COUNCIL ASSESSMENT REPORT

Panel Reference	PPSSTH-141
DA Number	DA-2022/14
LGA	Wollongong City Council
Proposed Development	Demolition of existing building /structures and construction of an 18 storey mixed use development including hotel
Street Address	24-30 Kenny Street, Wollongong
Applicant/Owner	TFR Pty Ltd
Date of DA lodgement	5 January 2022
Total number of Submissions	31
Number of Unique Objections	First round of notification between 2-17 February 2022 and received 22 submissions (including 1 letter of support) Second round of notification following the submission of revised plans between 13-27 July 2022 and received a further 9 submissions.
Recommendation	Approval
Regional Development Criteria (State Environmental Planning Policy (Planning Systems) 2021 – Schedule 6 Regionally significant development)	Clause 2 General development over \$30 million Under Schedule 6, general development over with a capital investment value (CIV) of more than \$30 million is identified as regionally significant development. The CIV values the proposed development at \$30,617,000 (excluding GST).

Figure 5: Morning shadow diagrams in midwinter

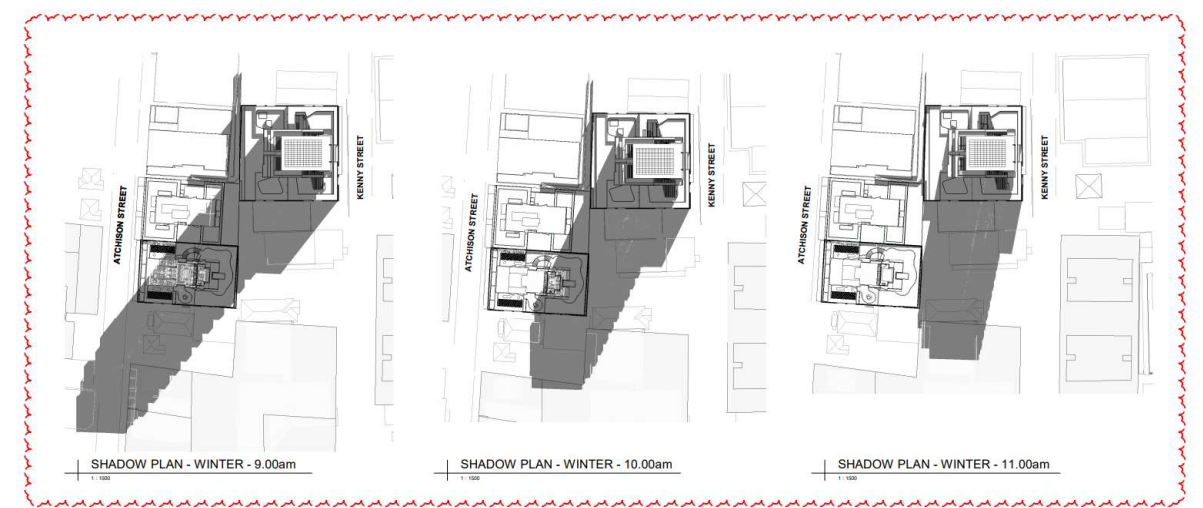
The plans show that by 11am, the shadows cast by the building will no longer impact these sites. It is recognised that the design of these buildings has units oriented to the west and to the east to receive either morning or afternoon sunlight access, given that they are currently overshadowed by the existing buildings to their north. However, in the city centre context sunlight access is more difficult to protect where the planning controls anticipate large buildings. This is exacerbated by the east west orientation of the lots. Substantial changes to the proposed building would be required to remove overshadowing impacts. Given the building is consistent with the form of development and the building envelope expected on the site, requiring design changes is not considered reasonable.

Figure 10: Indicative view arc from 27 Atchison Street impacted by the proposed tower

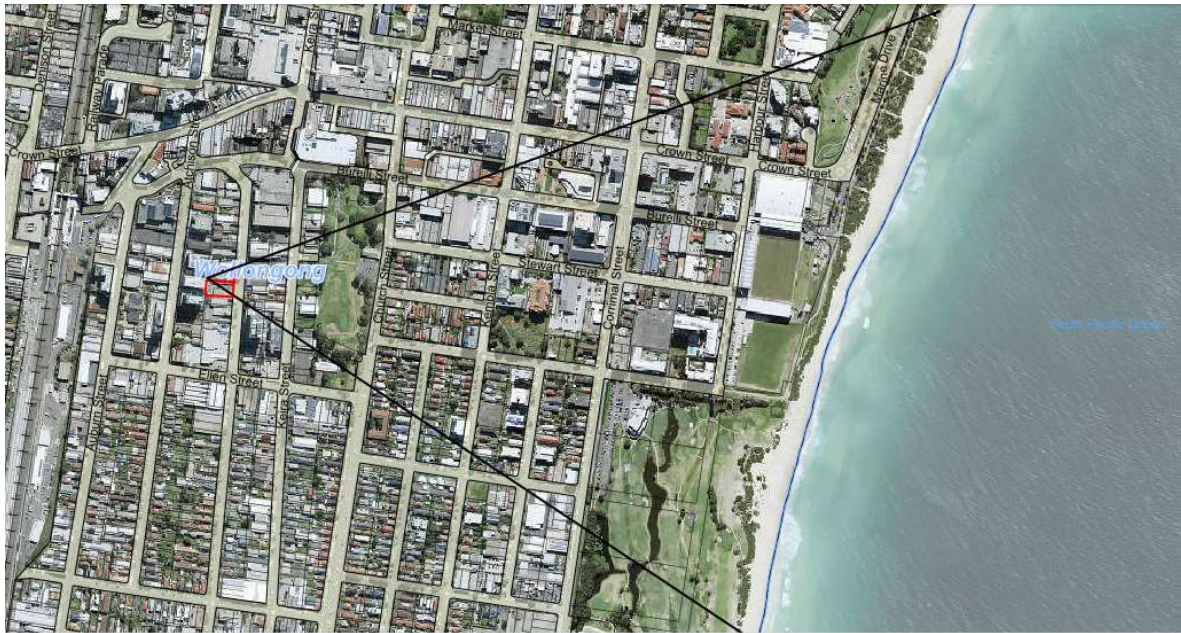
As a proportion of the views lost, the impact on views lost are likely to be moderate to severe. Some coastal views, including views in which the interface between land and water is visible, would be retained after construction of the proposed development based on the existing built form to the north and south of the site. However, redevelopment of sites in the vicinity of the subject site will occur over time and further view loss is likely to occur.

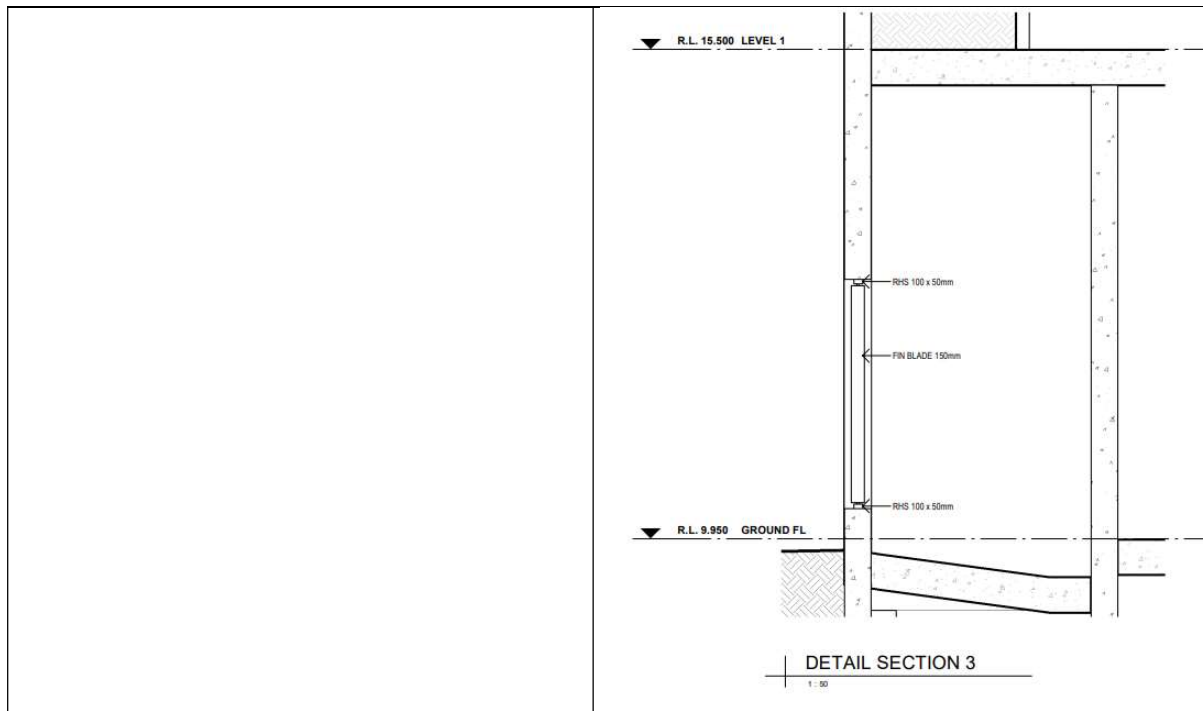
The overland flow paths adjacent to side boundaries must be secured and concealed. Details of the garage door and gates / fences proposed fronting Kenny Street should be provided, together with finished levels, to demonstrate how overland flow is achieved, whilst providing a positive contribution to the aesthetic of the street. Direct views down the drainage passage, from the street must be minimized. Maintenance access should be indicated.	<p>Balancing the flooding constraints while providing an appropriate built form outcome, and minimising safety and security issues has been a recurring theme during the assessment.</p> <p>An appropriate response has been put forward that manages these issues in an acceptable way however, this will be subject to further detail being provided prior to issue of a Construction Certificate. The applicant's engineer has proposed a screening system to the western, northern, and southern boundaries that incorporates horizontal battens, and a sliding mechanism that incorporates a sensor trigger to open in the event of a flood. This will limit unauthorised access to the site, provide visual screening to these elevations while allowing for the flow of flood water when needed.</p> <p>A detailed section of the vertical blades to the front façade of the building has been provided, as shown below:</p>

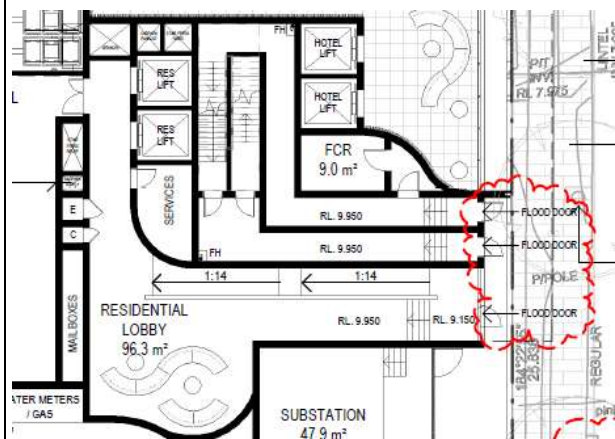
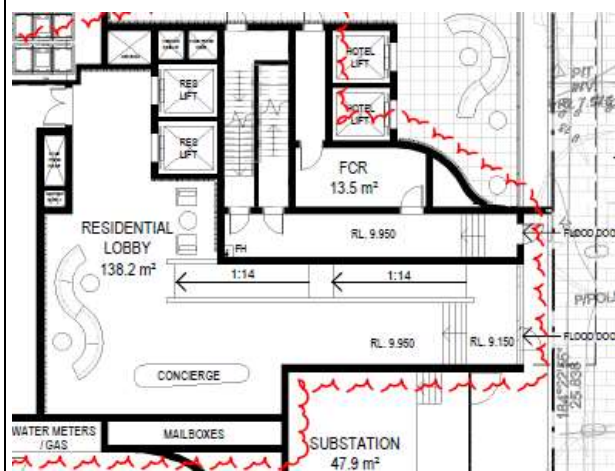
The residential entry and street/address presence is disproportionately constrained for the magnitude of the apartment use. It consists of a long narrow space that relates poorly to the lifts. It is recommended that the Fire Control Room be relocated further south (perhaps behind the substation), which would allow egress corridors to be located further north. This will create more space to accommodate a more generously proportioned residential lobby, that better relates to the lifts. The option of integrating the ramp and pedestrian entrances for at least some extent should be explored.

The residential lobby has had some design changes. The narrow, constrained lobby design that led to the Panel's concerns is shown below:

The lobby has been redesigned as follows:

Although the lift location has not changed, the lobby has more generously proportioned circulation areas with direct lines of sight to seating now available.

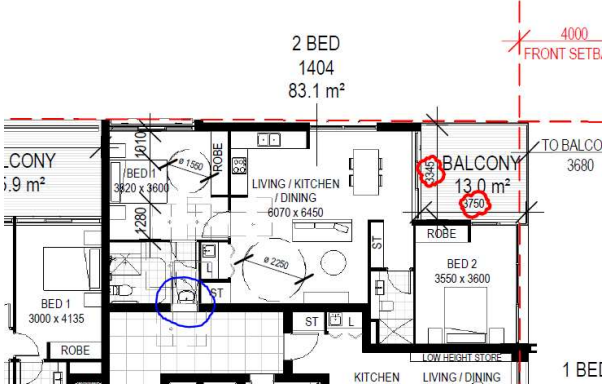
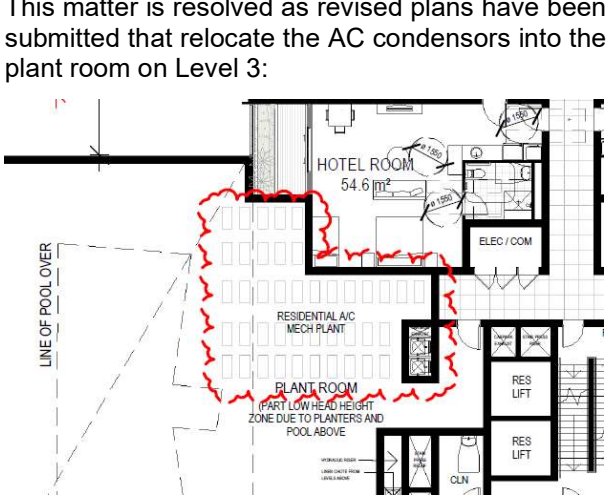
<p>Level 4 COS</p> <p>The expansive undercroft spaces are problematic for amenity; they will require careful, high quality detailing, selection of materials and finishes. The Panel acknowledges that enclosing more of these spaces is constrained by FSR requirements but considers that they will only be acceptable if they are well lit and ventilated and finished with high-quality materials that integrate the indoor and outdoor spaces well. Dividing the spaces from the outdoor areas may not be the best option for achieving this.</p> <ul style="list-style-type: none"> - The function of the outdoor space on the southern side of the building is unclear. Why would anyone go there to sit on artificial turf when other spaces, including their own balconies, offer much higher amenity? Options for activities that invite residents to use this space should be explored (e.g., a community garden; outdoor gym or mini sports field; dog play area...) - The inclusion of numerous planters under the roof space is strongly questioned. They are very poor in terms of sustainability, requiring special lighting, artificial irrigation and frequent replacement of plantings that fail due to the poor growing environment. The lay-out of southern and northern plantings should be reconsidered and alternatives to the extensive plantings around the swimming pool explored. - The Panel does not support the use of artificial turf except for particular circumstances where no suitable alternatives are available. It is not clear that this is the case with the proposed design. 	<p>The landscape plans indicate reasonable treatment of the Level 4 areas. Additional detail will be required for the landscape screening along the western edge of the pool to address privacy between this space and western neighbours. A condition is recommended for suitable species and ongoing maintenance to be submitted as part of the final landscape plan.</p> <p>The southern area of COS is indicated as artificial turf proposed as a stretching area. Without some further detailing this space is unlikely to be highly utilised. Given this area will not receive much sunlight, an outdoor gym, sportsfield or dog play area would be possible uses that could work. A condition is recommended for additional detail identifying further passive or active recreational uses to be shown and included as part of the final landscape plan.</p> <p>Given the landscape screening around the pool may not thrive in these conditions, a solid screen along the western side should also be provided to address amenity and privacy between adjoining properties.</p> <p>See previous comments requiring additional detail on the programming of this space.</p>

<p>What is the role of the artificial turf? What other options are possible for the ground treatment in this location?</p> <p>The documentation should show all proposed boundary fencing and clearly indicate how the existing wall that is to be retained along the northern boundary will be treated.</p>	<p>A solid masonry wall is proposed along the northern boundary of the site to prevent overland flow into adjoining site. This wall is shown on the elevation plans.</p>
<p>Detail treatment of the pool perimeter is required to demonstrate how privacy issues with western neighbours are resolved</p>	<p>See previous comments – a condition for a solid screen is recommended to provide a design solution that addresses this issue.</p>
<p>Unit identification numbers are required on the plans. Adaptable and Livable apartments noted on the Summary sheet (Dwg 000 W) cannot be located.</p>	<p>Updated plans identify unit numbers.</p> <p>Adaptable units #06 are located in the north-eastern corner however are not clearly notated as such. Liveable units are #03 but are also not readily identified. A condition is recommended for the plans to identify the relevant units as adaptable and liveable prior to issue of the Construction Certificate.</p>

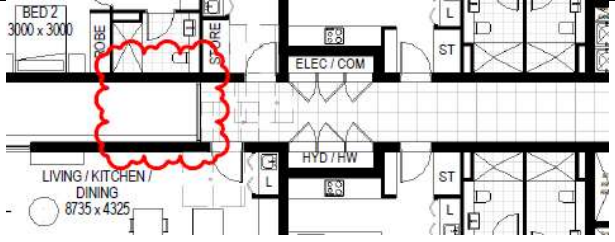
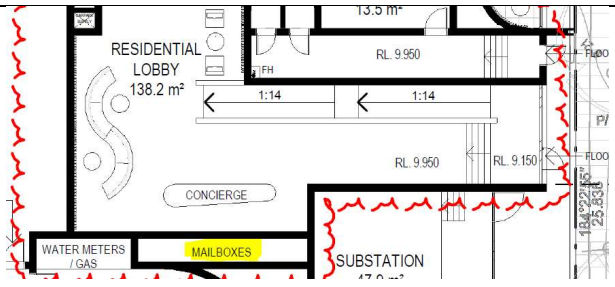
<p>The north-eastern corner units appear to be accessed via the bathroom. It is assumed that this is a drafting error, and that the entry door is located further east.</p>	 <p>This drafting error is required to be corrected as part of the Construction Certificate plans, noting that the units of Levels 5 and 6 with the same layout show the door positioned correctly.</p>
<p>Residential lobbies are serviced by a single window that will provide minimal outlook and natural lighting. AC condenser units have been located at the base of the lobby windows, further restricting natural light, outlook and creating a noise source that will further degrade the quality of the lobby spaces. The AC condensers should be housed in an alternative location, to maximise available natural light and ventilation.</p>	 <p>This results in natural light and outlook being available to the corridors:</p>

Figure 12: Section showing relationship of building to rear boundary and adjoining building at 27 Atchison Street

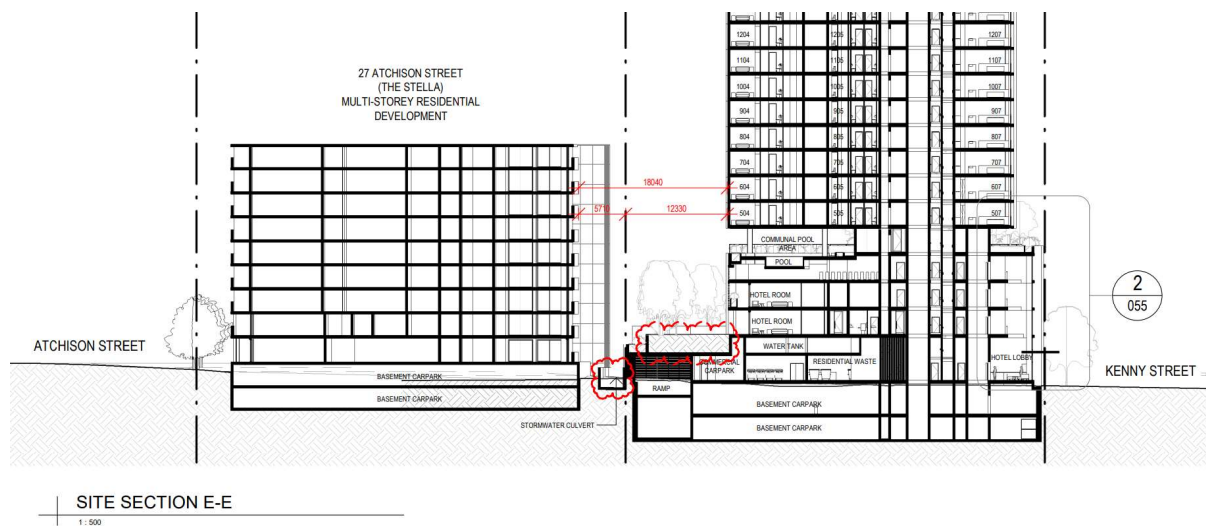
The development departures relate to the western (rear) boundary only, as shown in Figure 12 below:
